UNITED STATES  
DEPARTMENT OF THE INTERIOR  
BUREAU OF LAND MANAGEMENTFORM APPROVED  
OMB NO. 1004-0137  
Expires: January 31, 2018**SUNDRY NOTICES AND REPORTS ON WELLS**  
*Do not use this form for proposals to drill or to re-enter an  
abandoned well. Use form 3160-3 (APD) for such proposals.*5. Lease Serial No.  
NMLC062749B

8. Well Name and No.  
ZIA HILLS 19 FEDERAL COM 111H9. API Well No.  
30-025-44238-00-X110. Field and Pool or Exploratory Area  
WOLFCAMP11. County or Parish, State  
LEA COUNTY, NM**SUBMIT IN TRIPLICATE - Other instructions on page 2**

ConocoPhillips respectfully requests to change the approved drilling plan as reflected in the attached documents:

## DRILLING CONDITIONS OF APPROVAL

**BOPE Configuration & Specifications**  
**13-5/8" x 10,000 psi System**

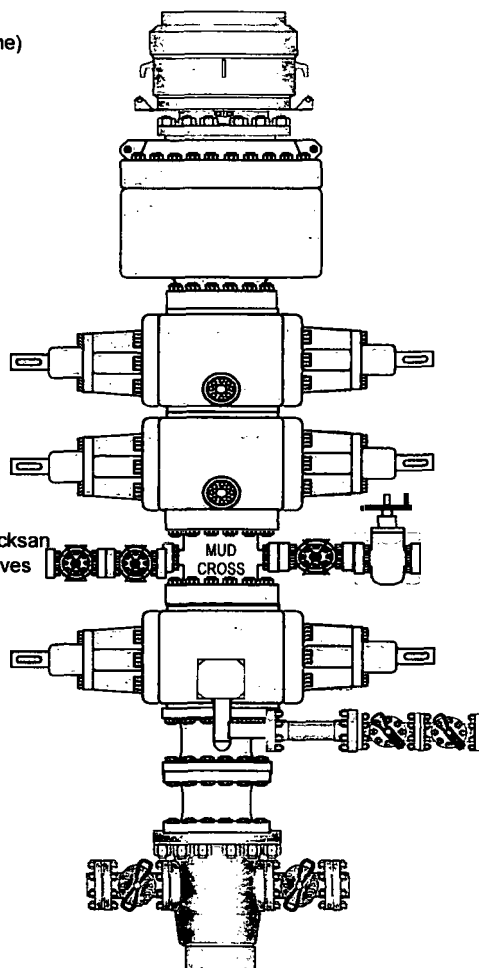
Zia Hills 19 Fed Com 111H Kelly Cock  
Zia Hills 19 Fed Com 111H Choke Manifold  
Zia Hills 19 Fed Com 111H BOPE  
Zia Hills 19 Fed Com 111H Casing Design  
Zia Hills 19 Fed Com 111H Cement  
Zia Hills 19 Fed Com 111H Drill Plan

- 1. Variance approved to use flex line from BOP to choke manifold. Manufacturer's specification to be readily available. No external damage to flex line. Flex line to be installed as straight as possible (no hard bends).
- 2. Minimum working pressure of the blowout preventer (BOP) and related equipment (BOPE) required for drilling below the surface casing shoe shall be **5000 (5M) psi**.
- 3. Minimum working pressure of the blowout preventer (BOP) and related equipment (BOPE) required for drilling below the **9 5/8** intermediate casing shoe shall be **10,000 (10M) psi**.

**the IBOP valves**

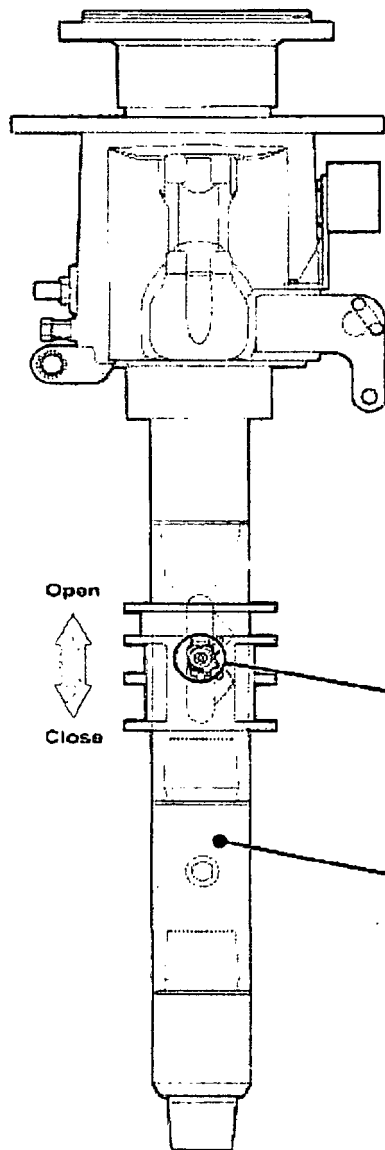
**Lower Kelly Cock and Upper Kelly Cock function are performed by Upper IBOP (Inside BOP) and Lower IBOP in Top Drive**
